Access Compliance Report

Public Rights-of-Way

(Curb Ramps)

Intersection ID: 11497	Main Street: MARGARET_BROWN_ST	Cross Street: S_IRWIN_AV	Location: NW
ADA ID: 3D52E91BC8F3	Ramp Type: Para	Initial Pass/Fail: Fail	Overall Compliance: No
Severity Score: 13.75			
Codes/Mitigation Info/Possible Solution		Field Measurements/Component Compliance

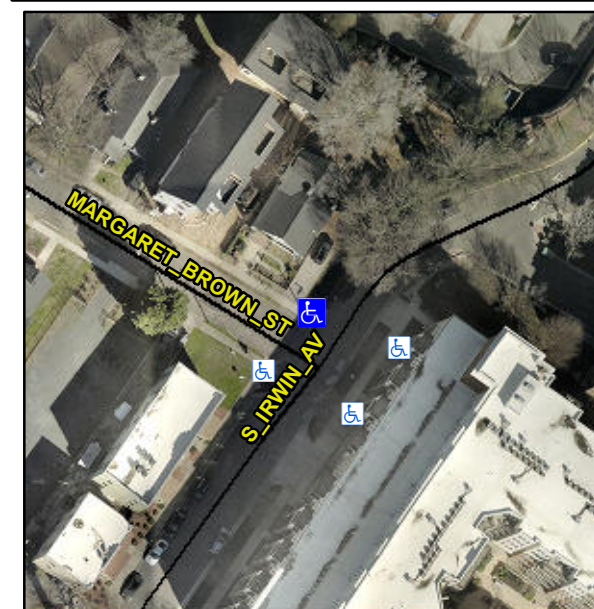
NO CURB LINE

PROW/ADA:

R304.3.2, R304.5.3

Possible Solutions:

Remove & Replace Entire Ramp.
